ADDENDUM NO. 1
November 3, 2020

- A. Brooks Stadium East Gates, H17-N123-MJ
Coastal Carolina University, Conway, SC

CCU BROOKS STADIUM EAST GATES CONWAY, SC

9 SOUTH GATE 4 ELEVATION SIGN
1/4" = 1'-0"

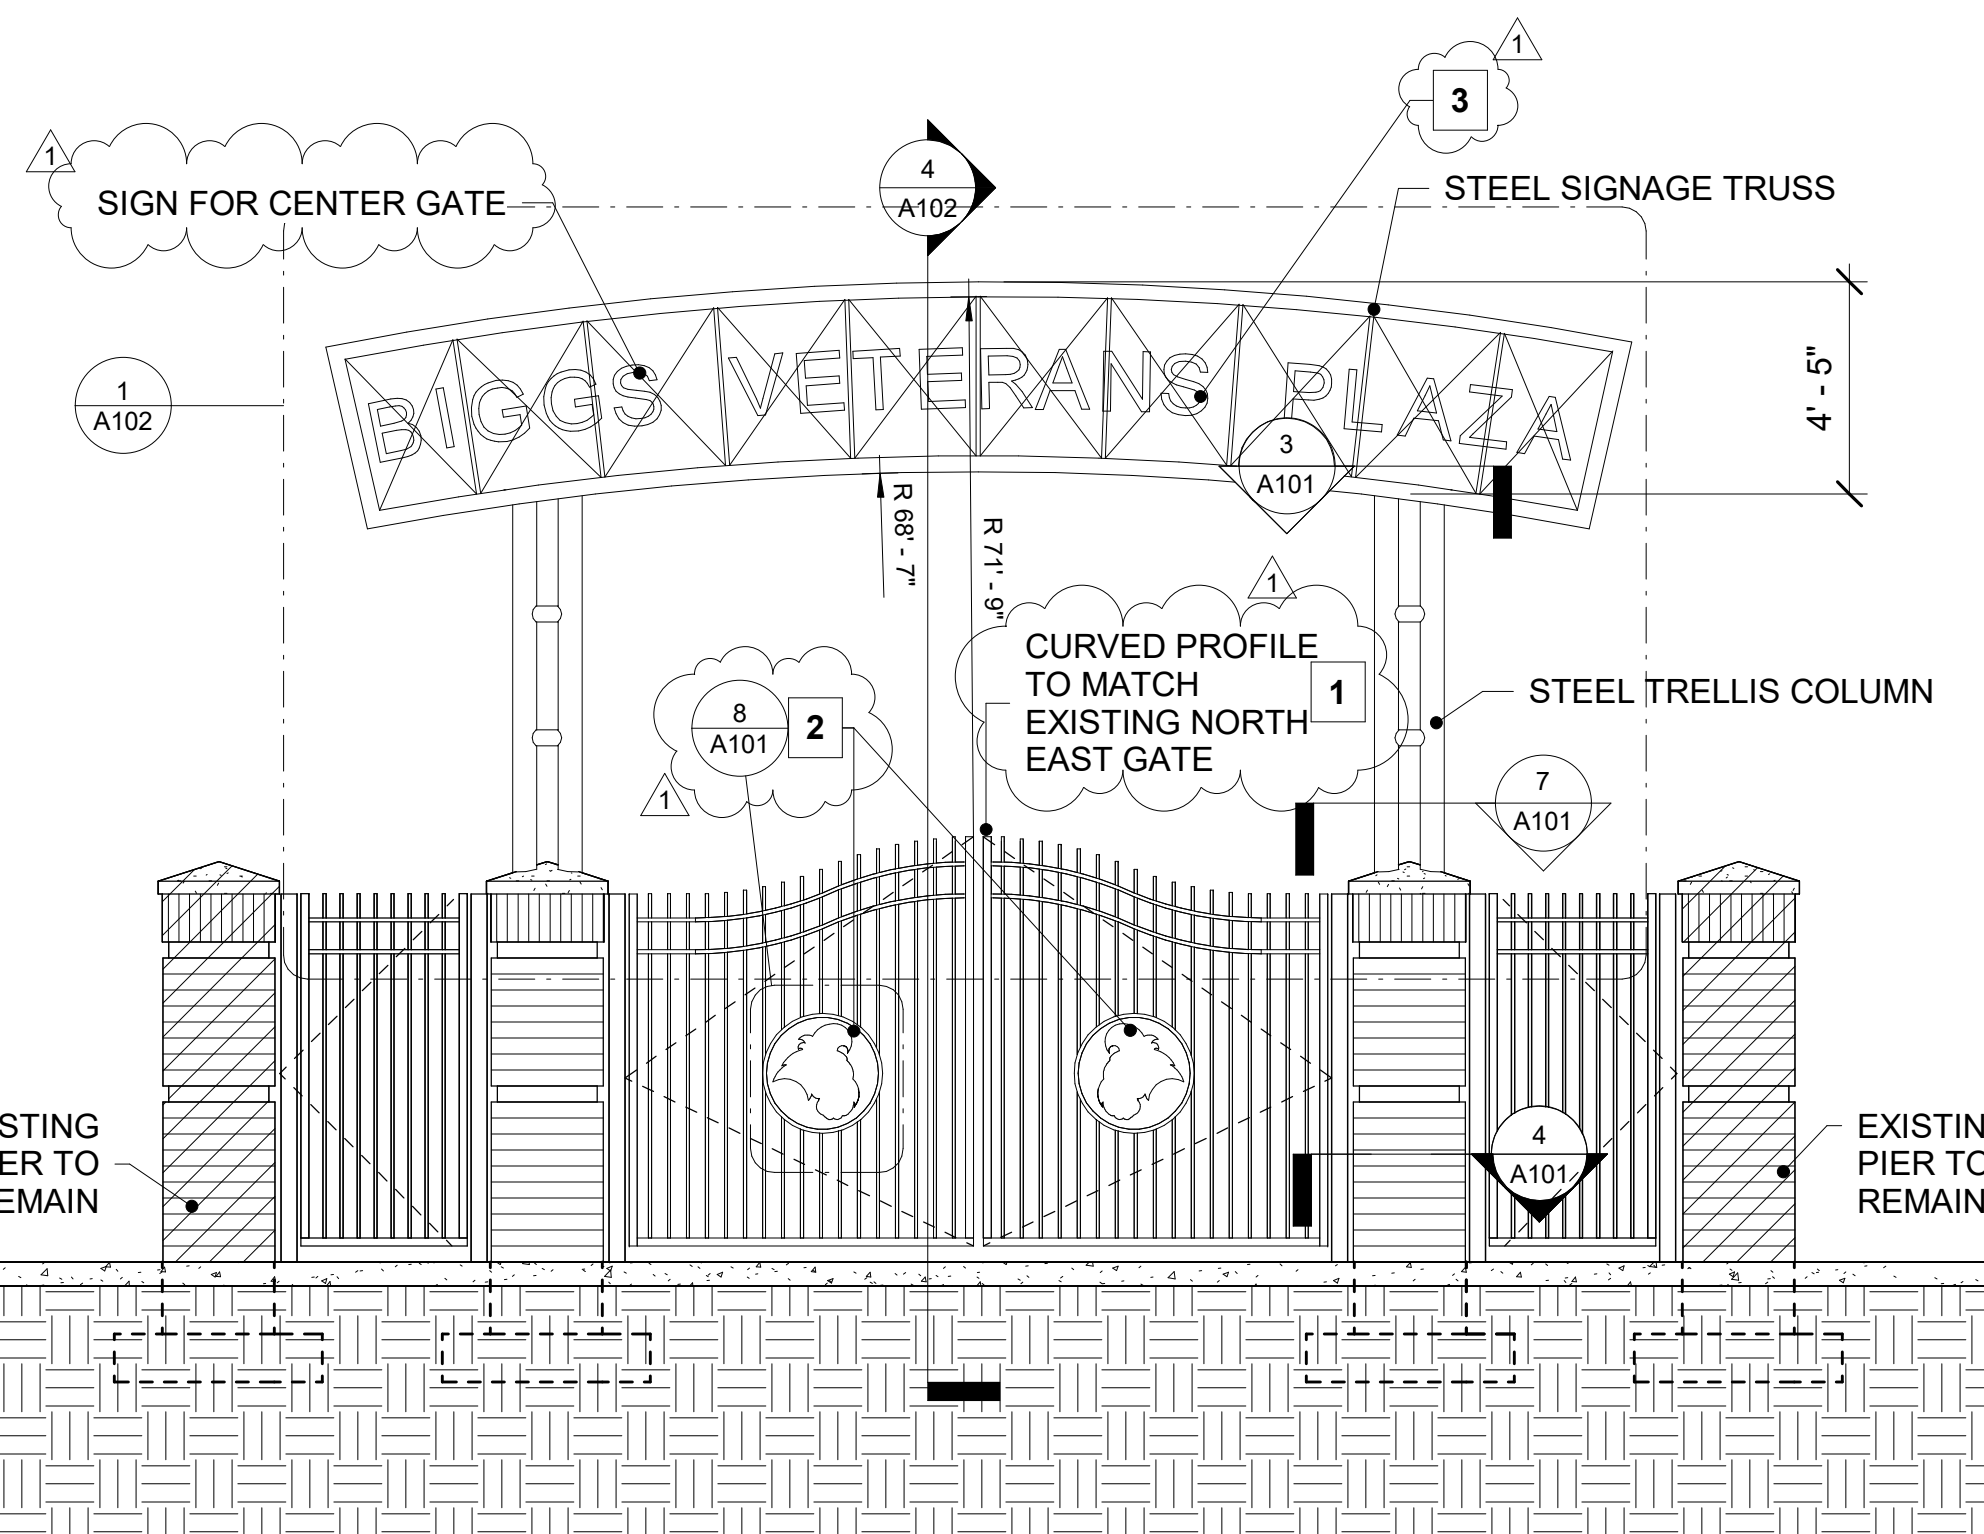
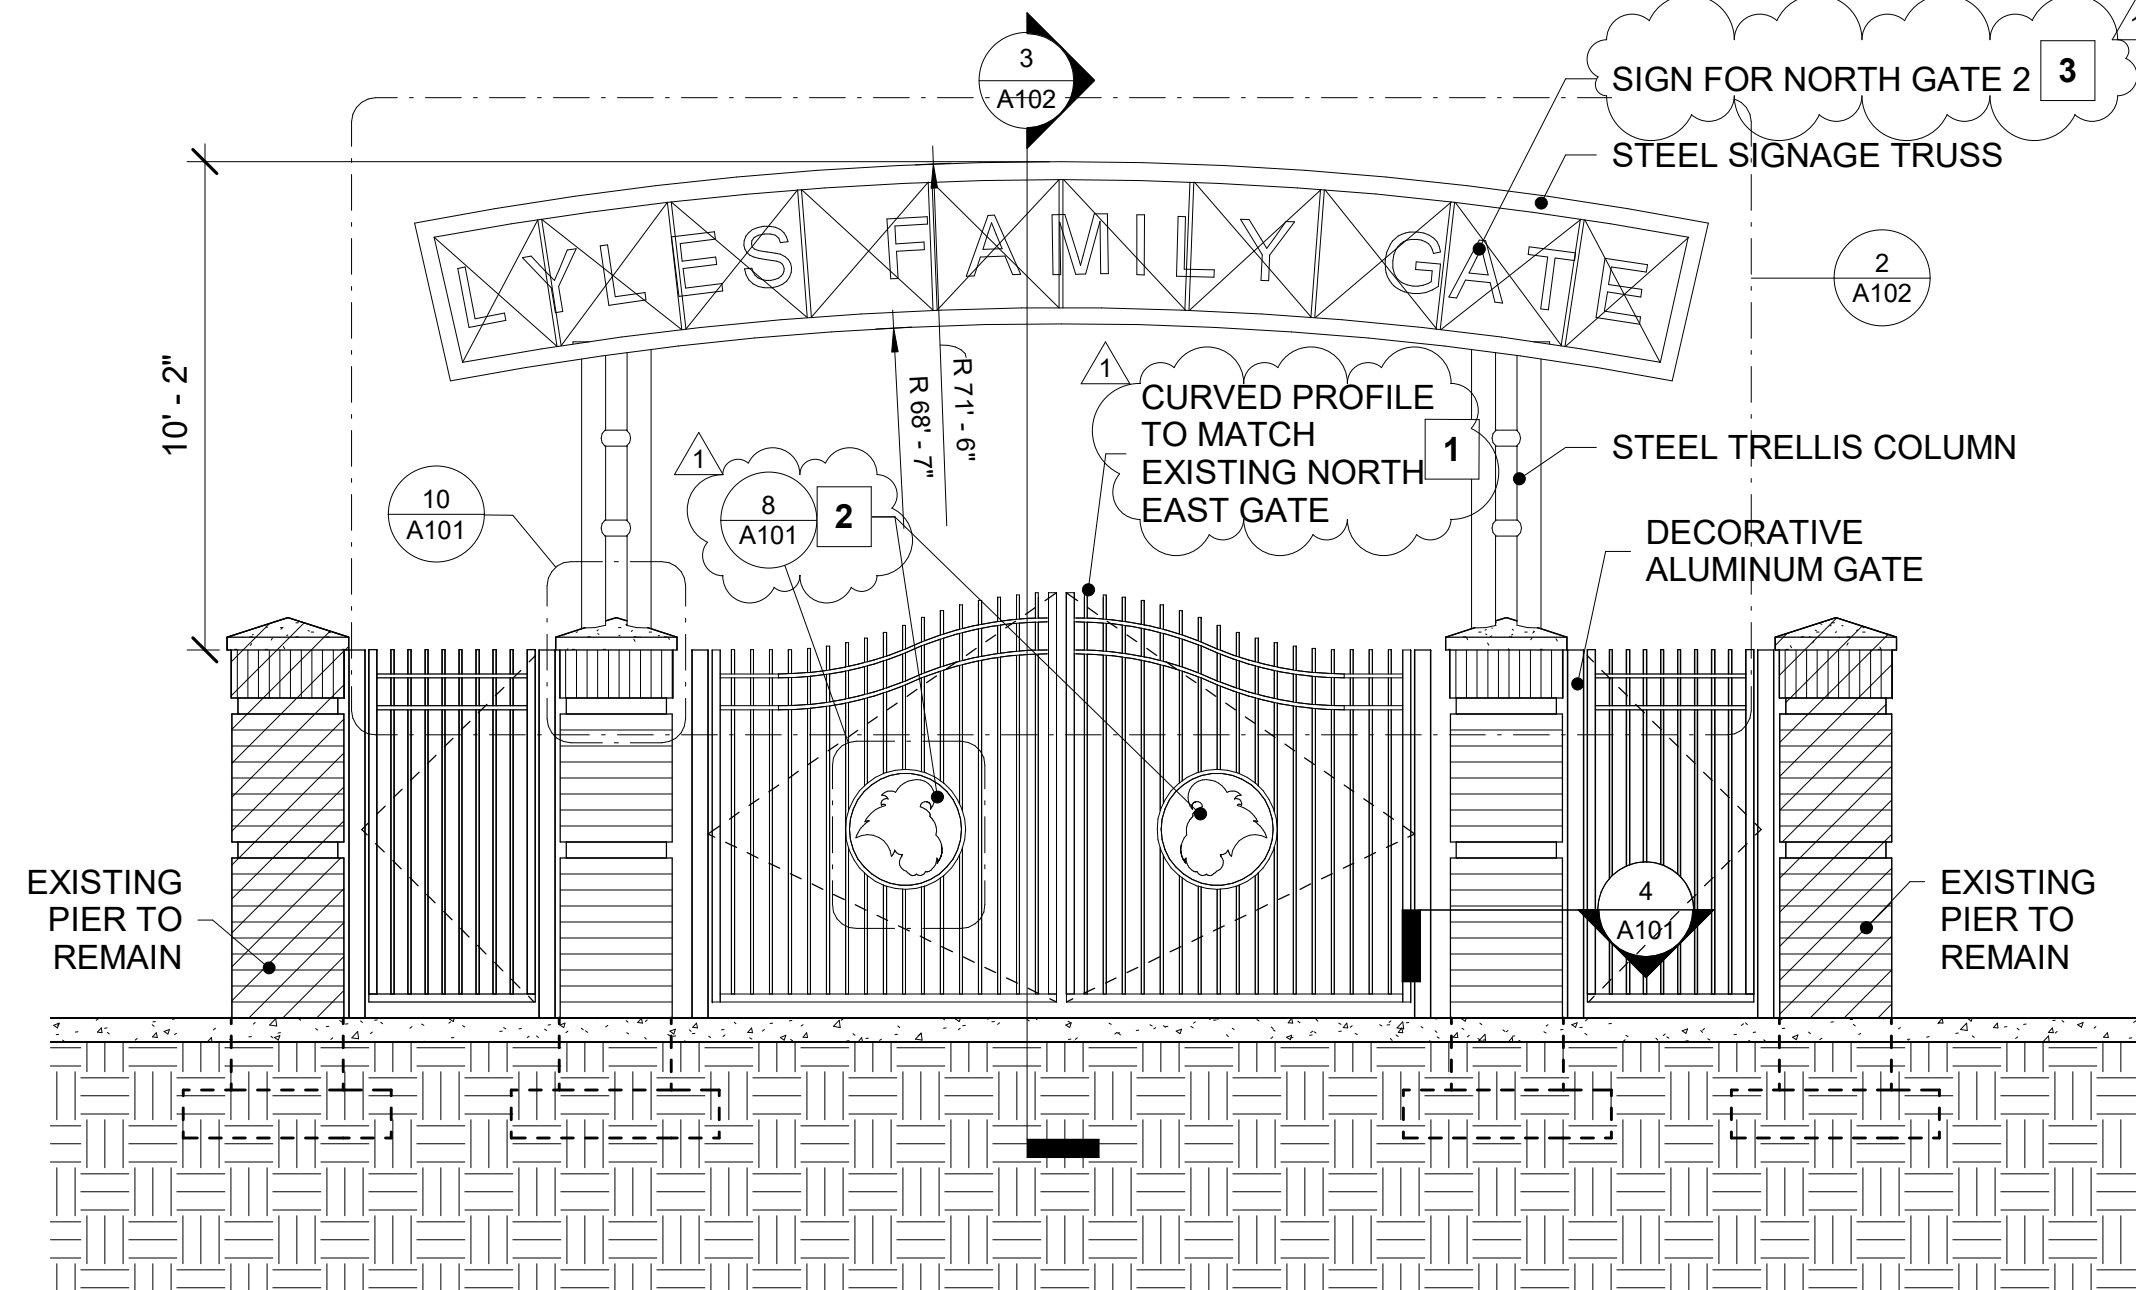
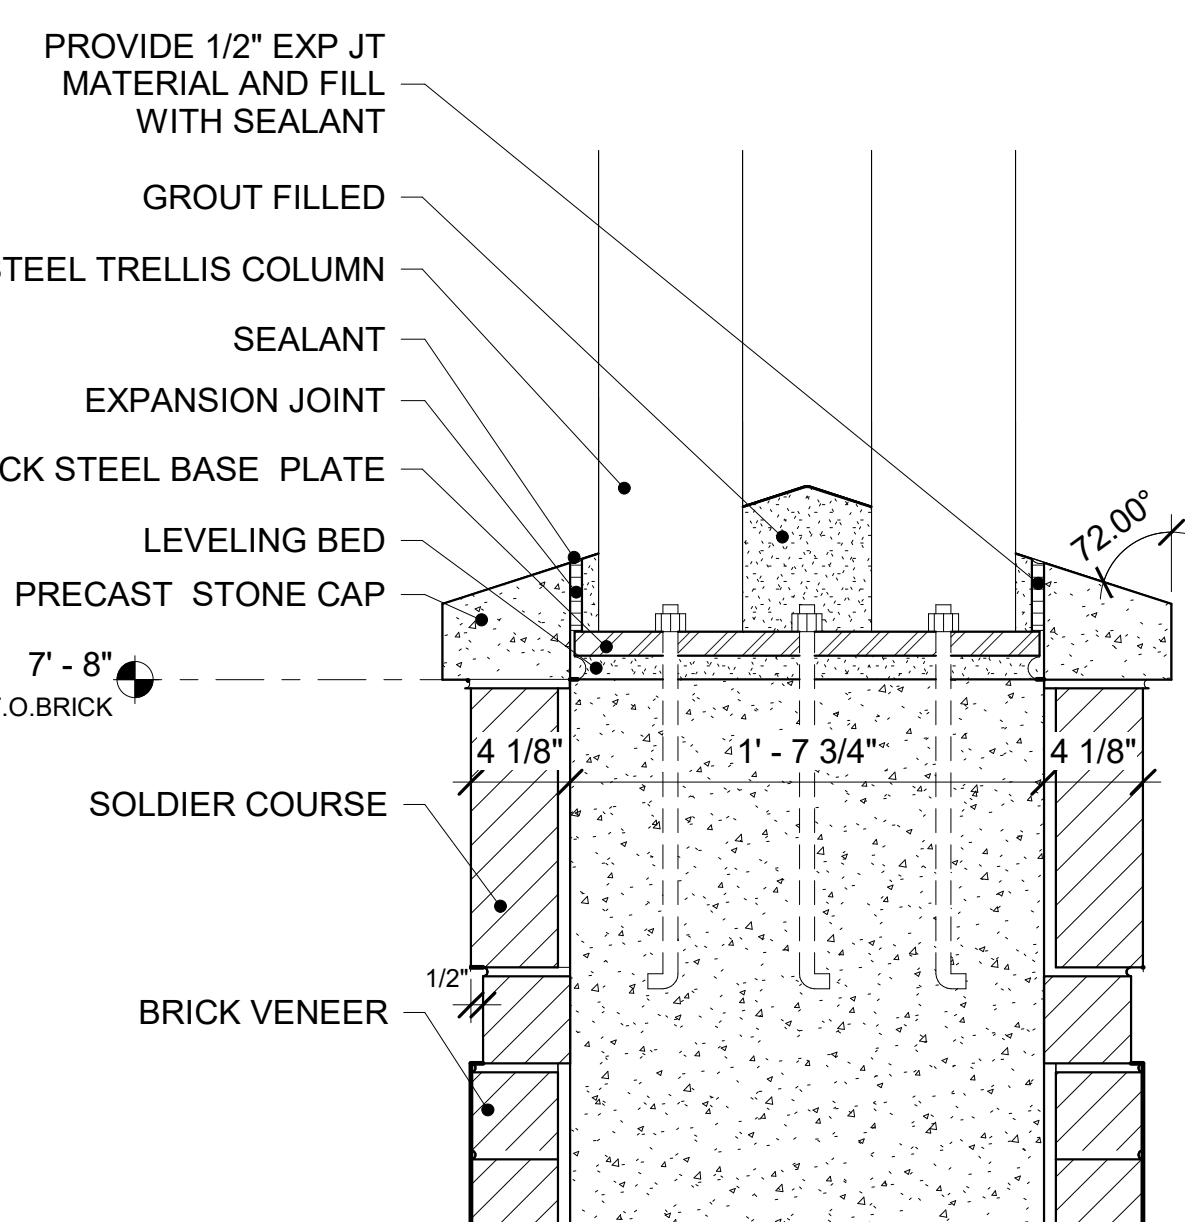
B. Sheet A101. Replace sheet with revised sheet A101 with 10/28/2020 revision date. A summary of revisions is as follows:

1. Clarified Gate Numbers on details.
2. Clarified extent of pavement and gate demolition.
3. Clarified extent of new concrete slab, control joints, and expansion joints.
4. Clarified logo requirements on gates and added detail.
5. Added signage and lettering requirements for each gate.
6. Deleted requirement for galvanizing steel fabrication.

- 1. NEW FENCE/GATE CONSTRUCTION TO MATCH EXISTING. PROVIDE ALL HARDWARE AND ACCESSORIES FOR COMPLETE INSTALLATION, MATCH EXISTING TYP. FOR ALL NEW GATES.
- 2. GATE LOGO TO BE SOLID MTL. PLAQUE WITH ATHLETIC DEPARTMENT CHANTICLER LOGO ATTACHED - BOTH SIDES OF FENCE. THIS PHOTO IS FOR REFERENCE OF STYLE ONLY. CONTRACTOR TO SUBMIT PROOF FOR OWNER/ARCHITECT APPROVAL.
- 3. INTERNALLY ILLUMINATED 16" CHANNEL LETTERS "BOOK ANTIQUA" FOTN.
- 4. 6" REINFORCED CONCRETE SLAB W/ 6X6XW2.9XW2.9 2" FROM BOTTOM SLAB.

- 1. REMOVE ALL EXISTING FENCING AND GATES BETWEEN EXISTING PIERS.
- 2. GATE POSTS AT EXISTING PIERS MAY REMAIN AND BE REUSED AT CONTRACTORS OPTION. REPAINT TO MATCH NEW WORK.
- 3. CUT AND REMOVE EXISTING CONCRETE SLAB BETWEEN WITH EXISTING CONTROL JOINTS AND BRICK PAVERS. REPLACE WITH NEW SLAB.
